Subject: Duane Arnold Energy Center  
Docket No: 50-331  
Op. License No: DPR-49  
Safety Parameter Display System (SPDS)

Attachment: Response to NRC Safety Evaluation  
Report - DAEC SPDS

Response to  
NRC Safety Evaluation Report  
Duane Arnold Energy Center Safety Parameter Display System

Request for Further Information Concerning  
Electrical Isolation

Figure 1

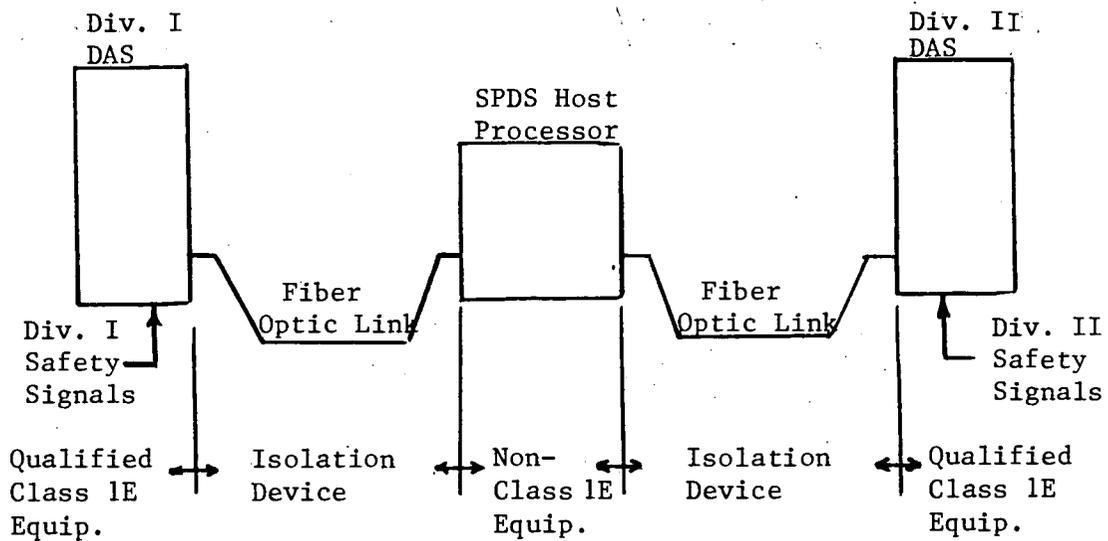
- a. For each type of device used to accomplish electrical isolation, describe the specific testing performed to demonstrate that the device is acceptable for its application(s). This description should include elementary diagrams when necessary to indicate the test configuration and how the maximum credible faults were applied to the devices.

- b. [Provide] Data to verify the maximum credible faults applied during the test were the maximum voltage/current to which the device could be exposed, and define how the maximum voltage/current was determined.

- c. [Provide] Data to verify that the maximum credible fault was applied to the output of the device in the transverse mode (between signal and return) and other faults were considered (i.e., open and short circuits).

d. Define the pass/fail acceptance criteria for each type of device.

e. Provide a commitment that the isolation devices comply with the environmental qualification (10 CFR 50.49) and the seismic qualifications which were the basis for plant licensing.

f. Provide a description of the measures taken to protect the safety systems from electrical interference (i.e., Electrostatic Coupling, EMI, Common Mode and Crosstalk) that may be generated by the SPDS.

Electrical isolation between the SPDS and the plant safety systems is provided with fiber optic communication links between the Division I and Division II remote Data Acquisition Subsystem (DAS) cabinets and the SPDS host processor (see Figure 1 below). The DAS cabinets provide analog to digital conversion and prepare all data (analog and digital) for transmission to the SPDS host processor over the fiber optic link. The divisional DAS cabinets, including all equipment within the cabinets, will be Class 1E qualified. These divisional DAS cabinets will be located in the Control Room area and will be used for termination of safety system signals. The divisional DAS cabinets are physically and electrically separated from each other as well as being separated from the SPDS host processor. Divisional separation of safety system signals will be maintained between existing plant sensors and the divisional DAS cabinets using electrical cable and raceway which will be installed per the guidance of Reg. Guide 1.75, rev. 2. With the above as background information, each of the six points of information requested by the Commission are addressed individually on the following pages.

Response: Electrical isolation between safety systems and the SPDS will be accomplished with the optical transmission of digital data from each of the divisional DAS cabinets to the SPDS host processor via fiber optic communication links. The fiber optic links are constructed of silica glass fiber surrounded by a Kevlar buffer tube and jacketed with Tefzel. These materials cannot propagate voltage or current transients or any electrical signal, and provide complete electrical isolation between the SPDS and the safety systems. Reg. Guide 1.75 separation criteria between the input terminals and output of the isolation device have been met with the use of optic links which are terminated in two physically separate locations. Since the fiber optic links are physically unable to support electrical transients, the links are not required to be electrically tested.

Response: The fiber optic links will be constructed from materials that cannot conduct electricity. The fiber optic links will not be tested against electrical transients.

Response: Per the responses to item "a" and "b" above, the fiber optic links cannot support electrical transients and are not required to be tested in this manner. Similarly, other faults normally considered with an electrical interface (i.e., shorts, open circuits, and grounds) will not affect the safety systems which will interface with the fiber optic link.

Response: With regard to electrical isolation, there are no pass/fail acceptance criteria for the fiber optic link used as the isolation device between the SPDS and the plant safety systems. The materials used to construct the fiber optic links are known electrical insulators and cannot conduct electrical transients. The fiber optic links are not required to be electrically tested.

Response The divisional DAS cabinets and the fiber optic communication links are located in the Control Room area which is a mild environment and are therefore exempt from the environmental qualification requirements of 10 CFR 50.49. The divisional DAS's will be seismically qualified to perform their function during and after the design basis seismic event used as the basis for plant licensing.

Response The fiber optic communication link between the SPDS processor and the DAS cabinets effectively isolates the nonsafety portion of the SPDS from the Class 1E divisional DAS cabinets. Within the Class 1E divisional DAS cabinets, the manufacturer employs transformer isolation coupling of the input for analog signals and optical isolation of the input for digital signals primarily for noise reduction and isolation of the incoming signals. These same features reduce the possibility of the SPDS contributing electrical or electronic interference to the existing safety systems.
